**Re: Flatiron Meadows Planning Area C Preliminary Plat, Amendment No. 2  
Comment Response Letter**

**FLATIRON MEADOWS – PLANNING AREA C  
PRELIMINARY PLAT REVIEW RESPONSE**

# FLATIRON MEADOWS PRELIMINARY PLAT, AMENDMENT NO. 2

Sheet	8
<b>OU2</b>	of 13
Date	JANUARY 27, 2017

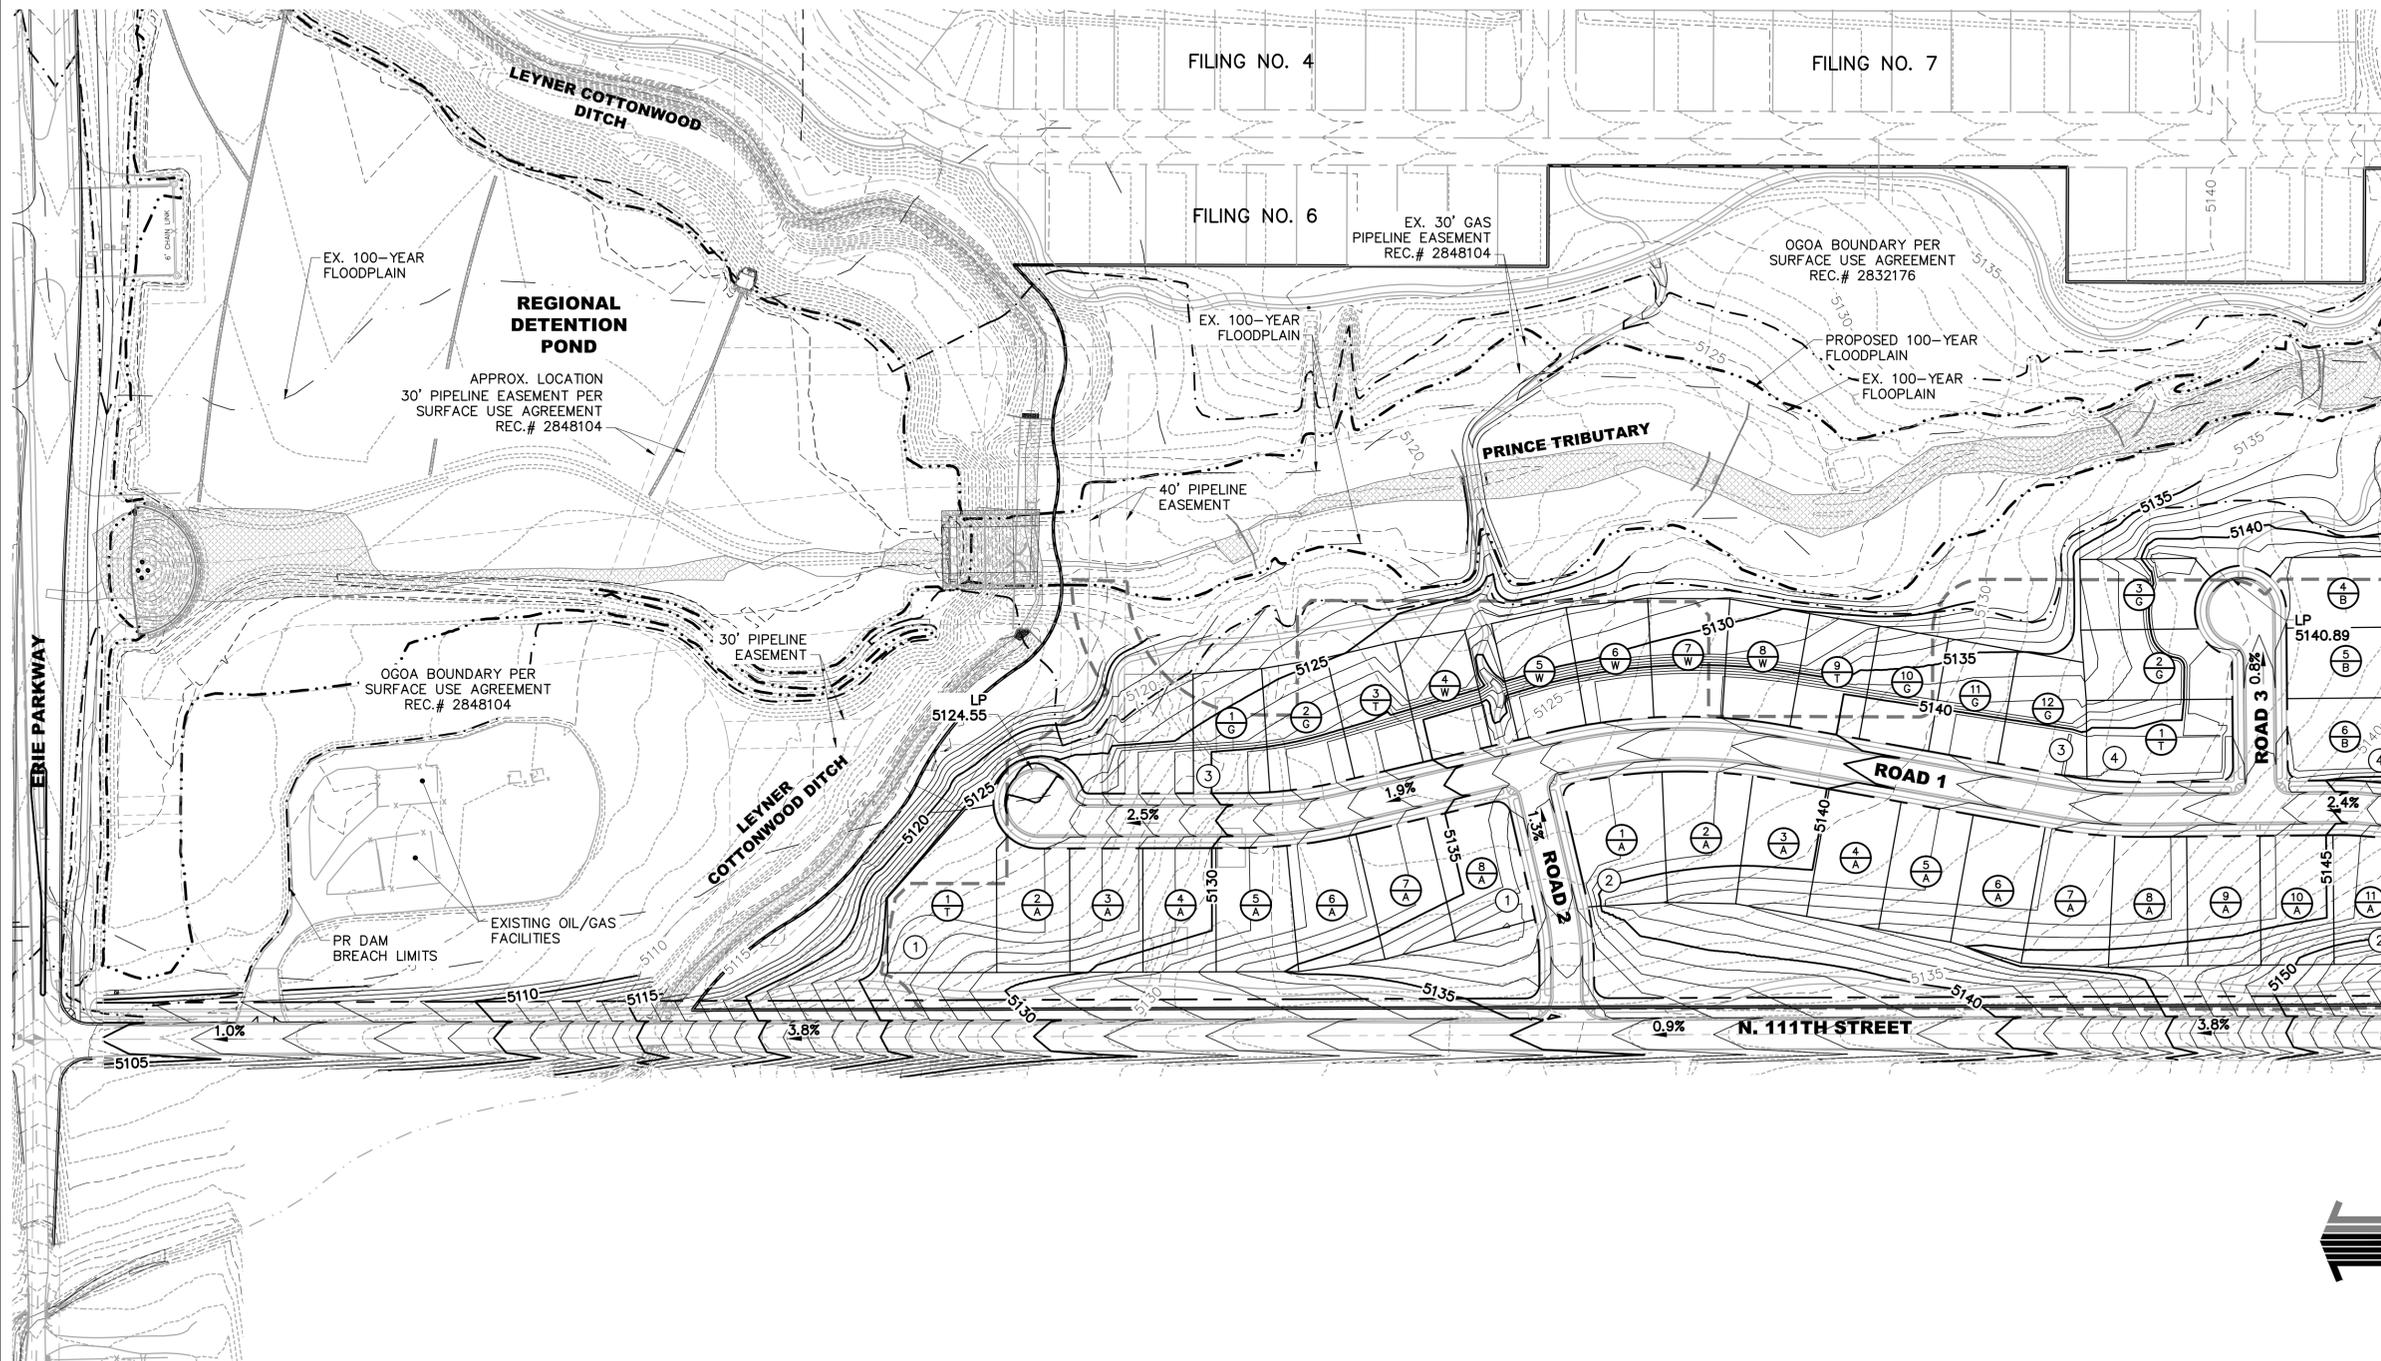
6. Sheet OU2 – Overall Utility Plan
  - a. The water line at the southern end of Road 1 that connects back to N. 111<sup>th</sup> Street is located in a tract 20' in width. Public utilities are to be located in a minimum 30' wide tract/easement.  
*Response: The water line and easement have been removed. The lots have been shifted west, and the water line now continues east of the cul-de-sac. The water and sanitary sewer lines are located in a 30' easement.*

- b. The sewer line at the southern cul-de-sac of Road 1 that connects around to future development to the south is located in an easement 20' in width. Public utilities are to be located in a minimum 30' wide easement.  
*Response: The sewer line is now in a 30' wide easement.*

- c. This same easement is partially located in the wetlands. Relocate easement outside of wetlands.  
*Response: The easement has been shifted west with the lot shift to obtain more clearance from the wetlands.*

Sheet	9
<b>GR1</b>	of 13
Date	JANUARY 27, 2017

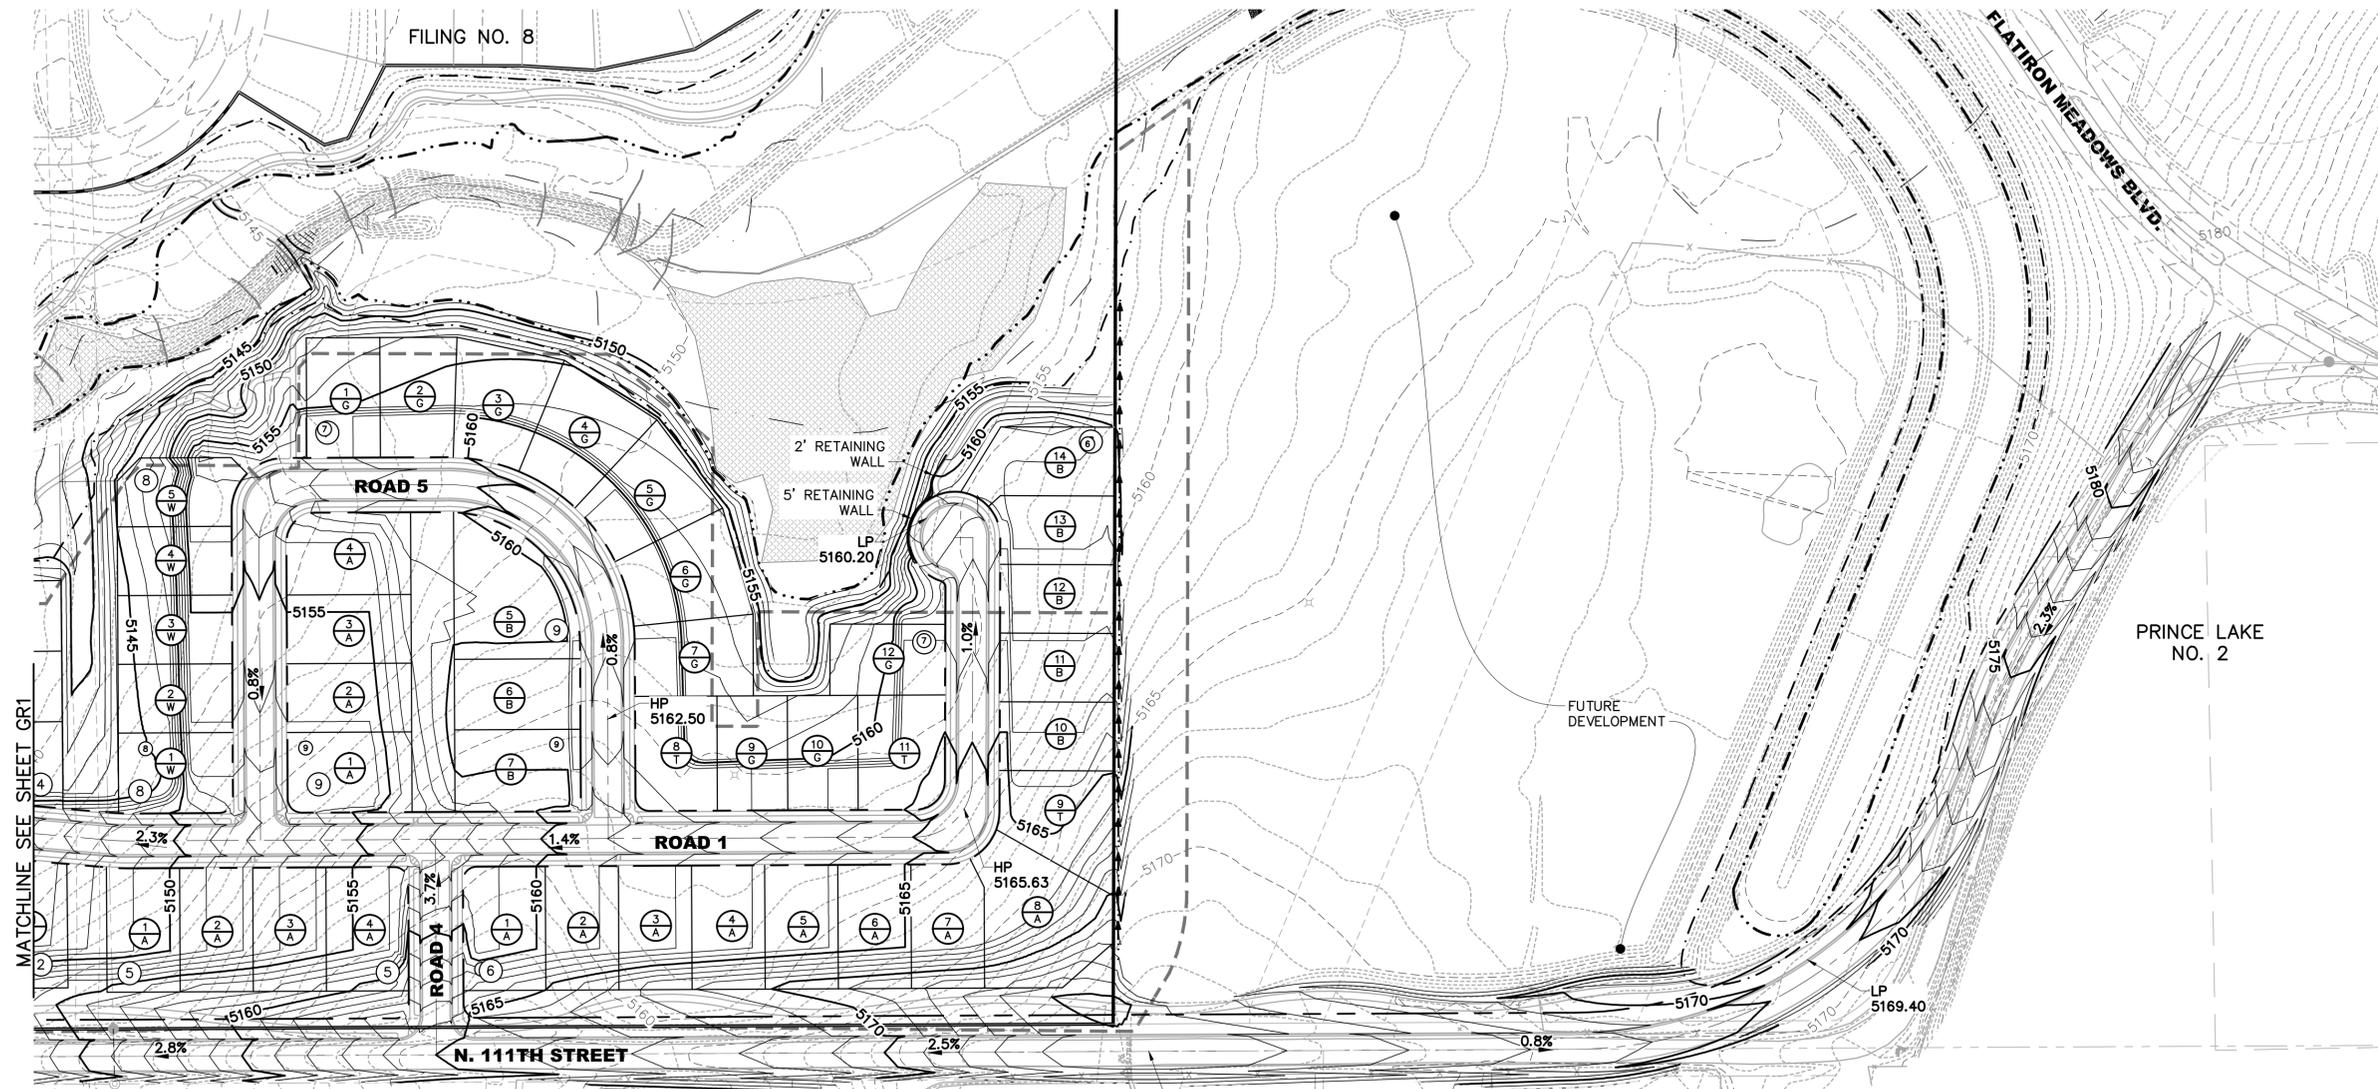
7. Sheets GR1 and GR2 – Grading Plans
  - a. *Note: Town comments were revised to reflected the revised grading plan submitted on January 10, 2017.* There is proposed fill in the 10' range on the north side of the subdivision and at the Road 5 bulb adjacent to open space. Naturalize any proposed grading along the open space corridor.  
*Response: Grades have been naturalized in the open space and do not exceed 5:1 slopes.*

- b. At Block 8, Lots 1-5, the adjacent Dam Breach elevation is the 45' contour which appears to go into the rear of lots. Adjustments may be needed to push the dam breach/grading outs of affected lots.  
*Response: The dam breach elevations change with the channel. The elevations shown at the section line are static and do not reflect the elevation at all points of a lot. The Dam Breach water surface has been modeled and compared to the final grading plan. We have verified that all points of the lot are above the Dam Breach water surface.*

- c. Adjust grades to accommodate cul-de-sac and mid-block trails and the pocket park.  
*Response: Grades have been adjusted to accommodate trails and the pocket park.*

- e. The grading adjacent to N. 111<sup>th</sup> St. north of Prince Lake No. 2 does not appear to match the dam breach grading shown in the regional drainage improvements. Also, the alignment of N. 111<sup>th</sup> St. is located in the 100 year floodplain limits and dam breach limits.  
*Response: The grading conflict has been corrected and the 100-year floodplain and dam breach limits are outside of the 111<sup>th</sup> alignment.*

- f. Contours do not coincide with the extents/limits of the flood plain and dam breach.  
*Response: The water surfaces limits have been updated to reflect the current grading.*

Sheet	10
<b>GR2</b>	of 13
Date	JANUARY 27, 2017

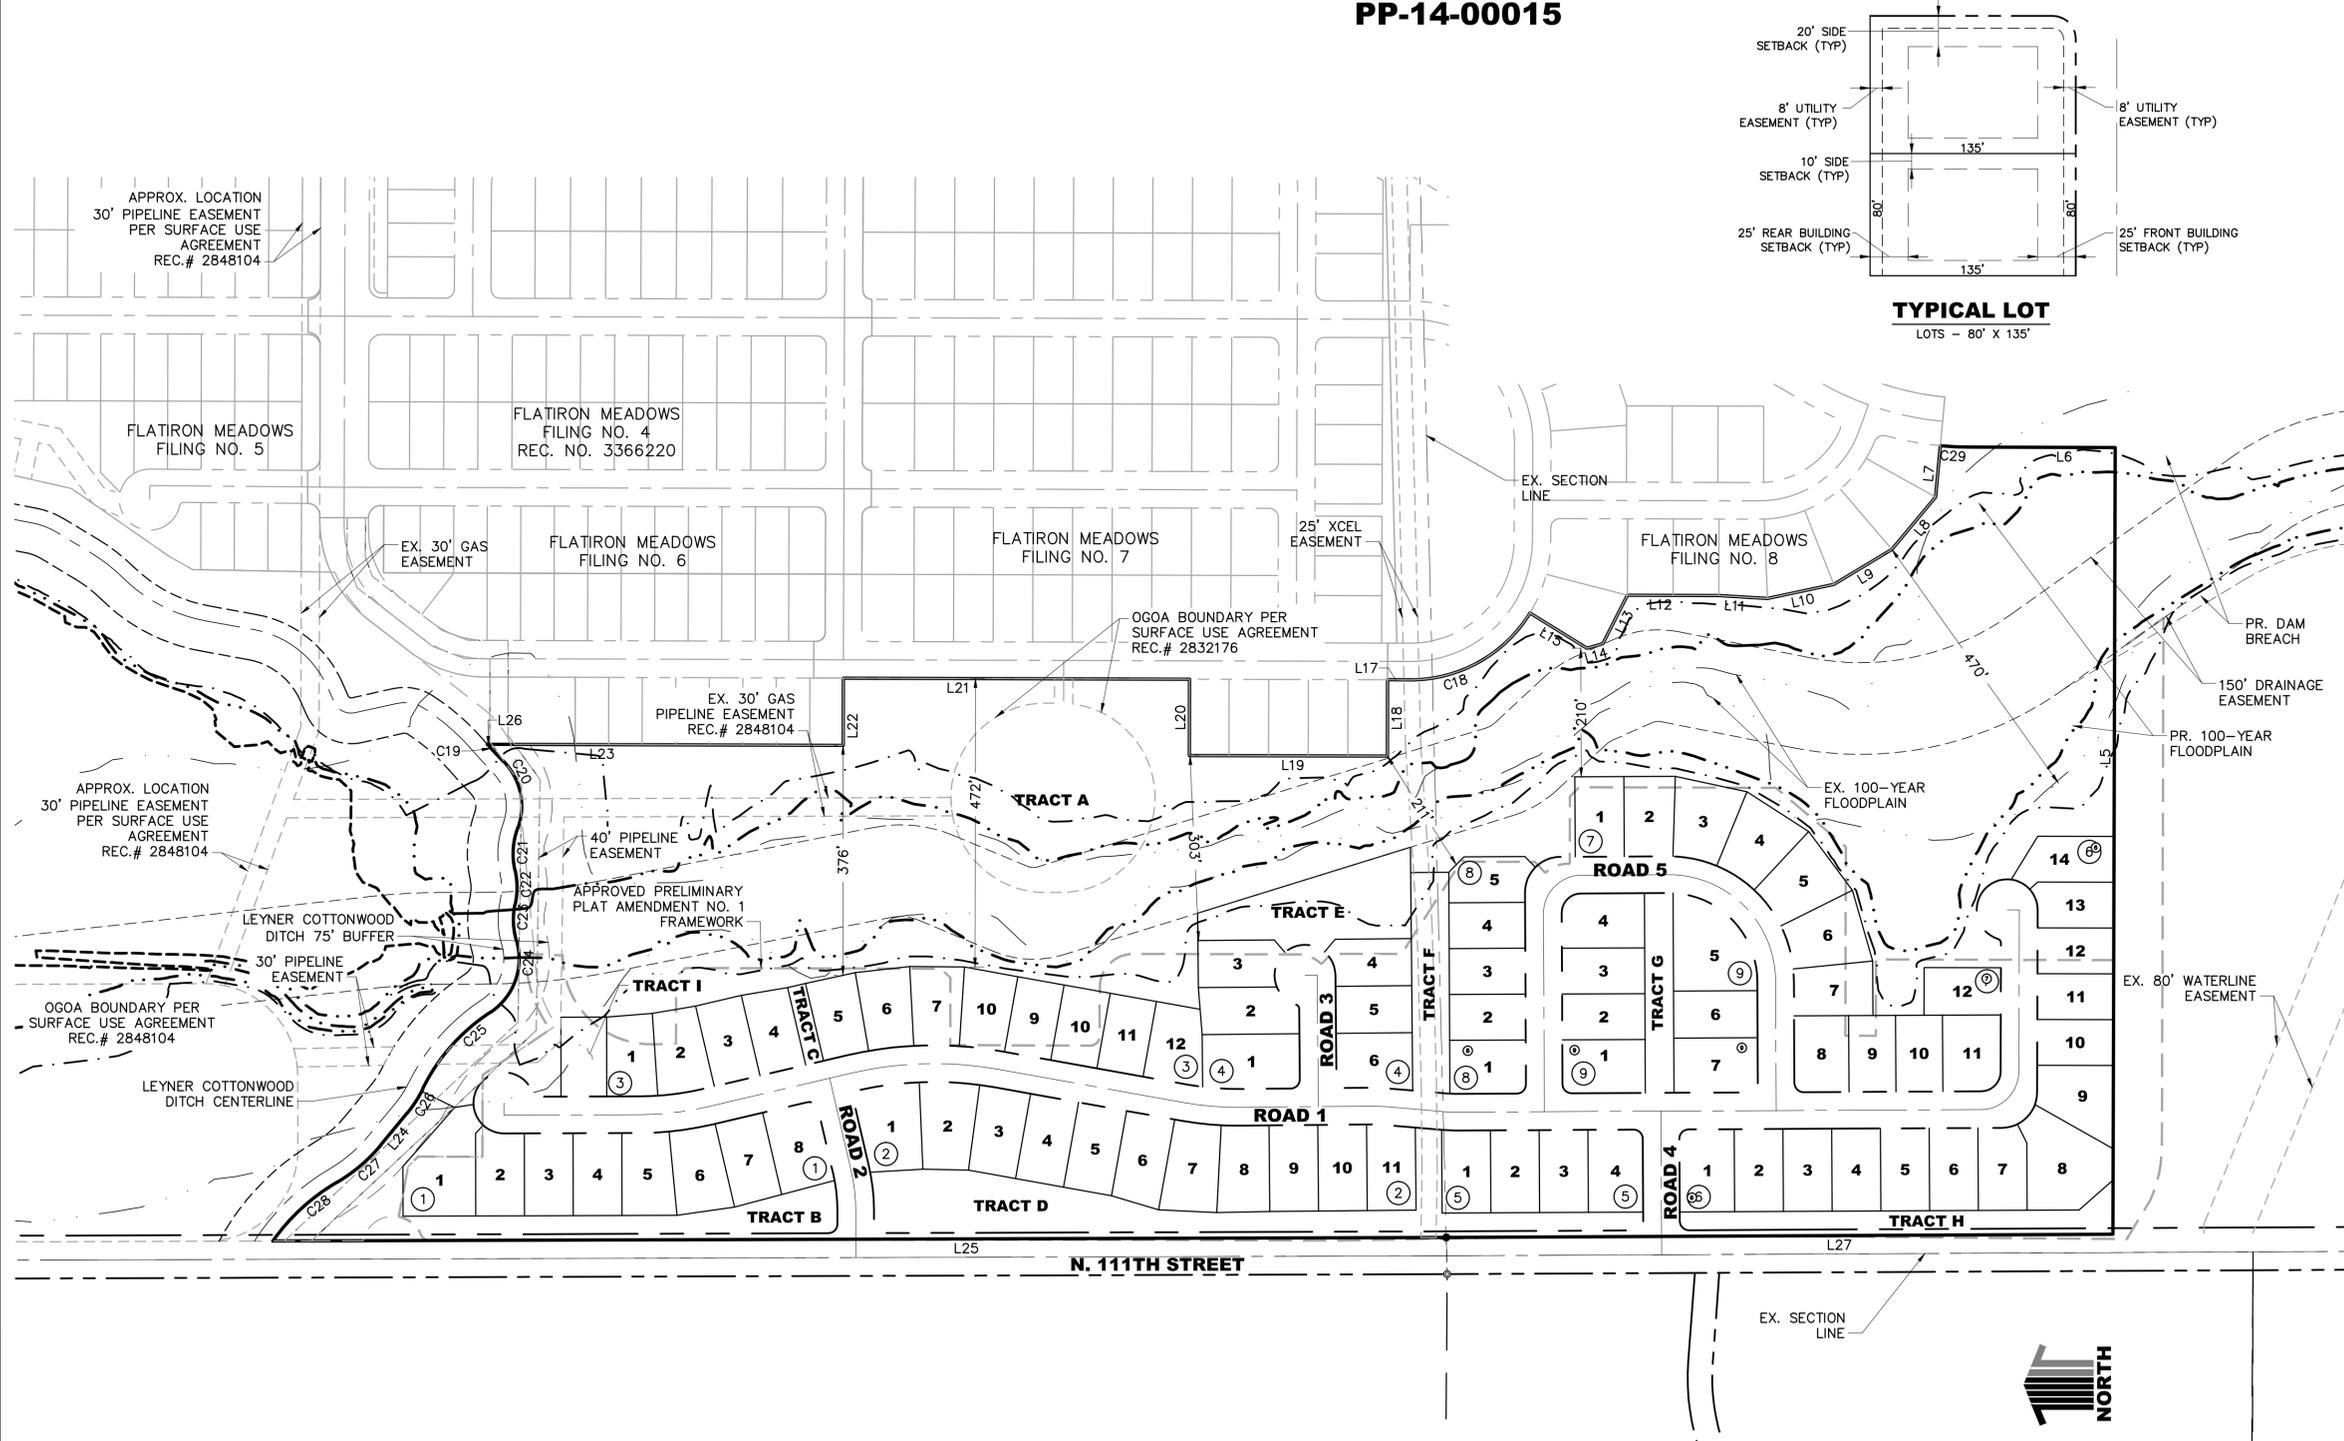
4. GR2: Provide retaining wall detail with basic design intent. Can be added to landscape details.  
*Response: Retaining wall details will be added with the final plat and final grading plans.*

3. **Prince Tributary West Branch flood zone, erosion, and setback.** Calibre states that changes have been made to the grading plan, and all proposed lots are now outside of flood zone limits. Sheet GR2, Grading Plan, shows a 4’ retaining wall behind approximately Lots 5 and 6, Block 7. CGS remains concerned about erosion and scour along constructed slopes within or adjacent to the flood zone, especially behind Lots 5, 8, and 9, Block 3, and Lots 1 and 4, Block 7 (depending on the location and length of the retaining wall called out on Sheet GR2). CGS continues to recommend that the applicant evaluate the need for retaining walls or slope armoring such as riprap to stabilize the slopes below these lots and reduce the risk of erosion, slumping, and localized slope failure.

*Response: Channel/slope stabilization will be reviewed with a geotechnical engineer with the final construction plans. Please reference attached ‘Response to CGS’ Comment Letter’ dated January 26, 2017 provided by CTL Thompson for official CTL Thompson responses.*
